**REMARKS/ARGUMENTS**

In response to the Office Action dated April 10, 2007, Applicants respectfully request reconsideration.

FIG. 2

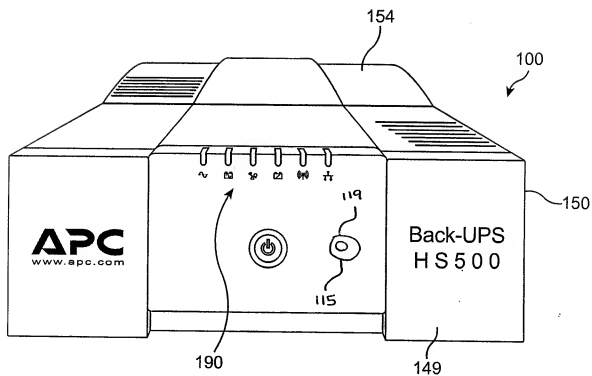
The drawings were further objected to for not showing every feature of the invention specified in the claims. FIG.2 has been amended to include a reset device of claims 5-6, and a pin hole. FIG. 4 has been amended to add the fastener and vertical wall of claims 2-4, and to show the mounting means of claims 7-17, as requested by the Examiner. FIG. 7 has been amended to include the reset device and reset line of claims 5-6.
